Service Information

Alternative service position for FL1 equipment

Service Information

1. General FL1

Fig. 7.1

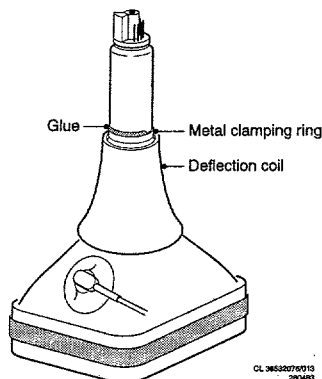
In order to prevent the deflection coil from dropping down following the replacement a projection tube the deflection coil should be firmly attached to the new projection tube. To achieve this adhesive 4822 390 30066 may be used. The adhesive should be applied to half of the tube's circumference (see Fig. 1), thereby coming into contact with the projection tube, the metal clamping ring and the plastic on the deflection coil.

Fig. 7.2

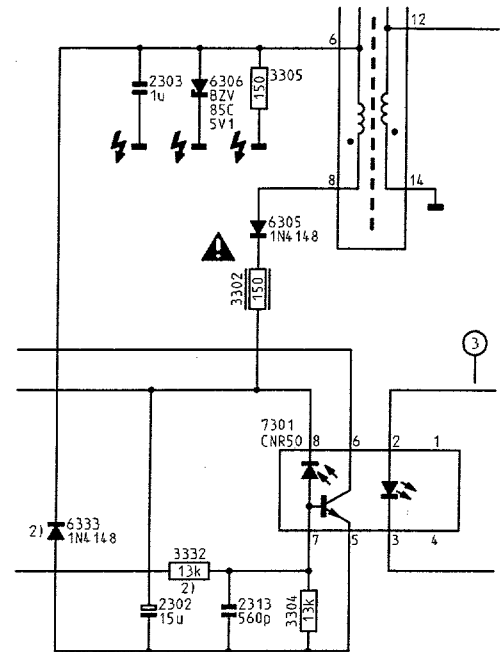
In service manual FL1-PTV AA a part of diagram x is incorrectly illustrated. This part is shown correctly in Fig. 2.
